UNITED STATES PATENT AND TRADEMARK OFFICE

09/869,784

Office Action Summary

DETAILED ACTION

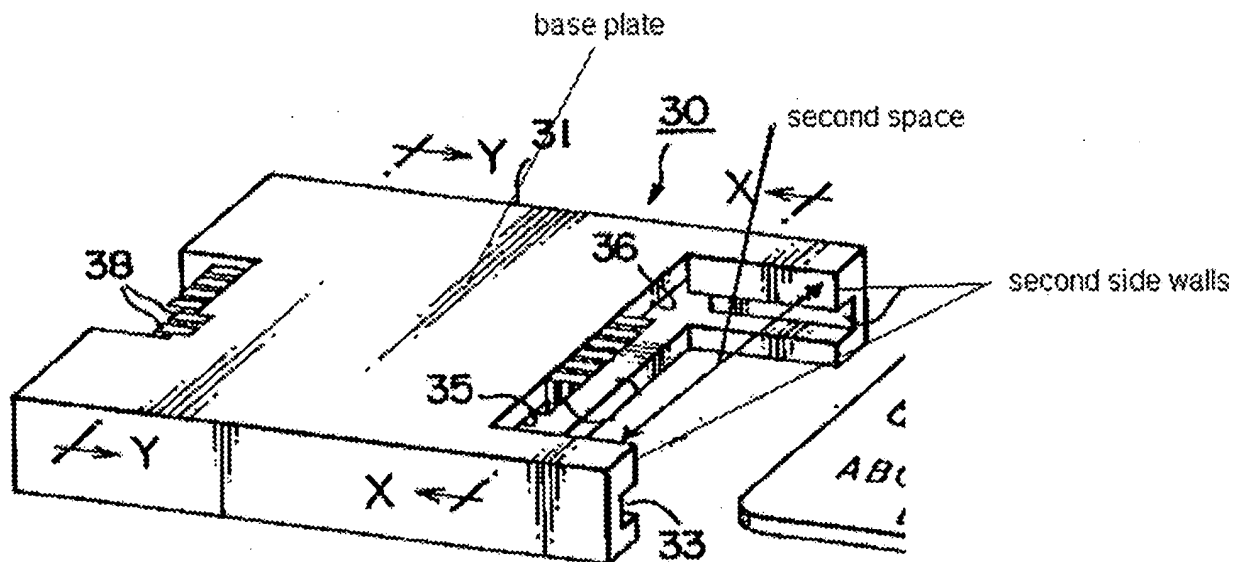
Hakoziaki discloses a card connector comprising a connector housing (30) having an upper wall (bottom of Fig. 1) and side leg portions (at 33, 34) adjacent to both ends of the upper wall, each side leg portion including first (at 33, 34) and second side walls and a step-like lower wall formed between the first and second side walls, a base plate (top in Fig. 1) adjacent to the leg portion, the base plate being opposite the upper wall, contact terminals (37) arranged on the base plate, to electrically couple with the contact pads arranged on the first and second cards, a first space defined by the upper wall, the first side walls, and the lower walls to hold side edge portions of the upper body portion of the first card and the body portion of the second card and to accommodate the upper body portion of the first card and the body portion of the second card, and a second space defined by the second side walls, wherein no portion of the base plate extends into the second space. Please note that recitations of the intended use of the claimed invention must result in a structural difference between the claimed invention and the prior art in order to patentably distinguish the claimed invention from the prior art. If the prior art structure is capable of performing the intended use, then it meets the claim. See *In re Casey*, 152 USPQ 235 (CCPA 1967) and *In re Otto*, 136 USPQ 458, 459 (CCPA 1963).

In response to Applicant's argument that Hokozaiki fails to disclose "a second space defined by the second side wall, wherein no portion of the base plate extends into the second space", please see the following figure, which shows the second side walls defining a second space and no portion of the base plate extending in the second space.
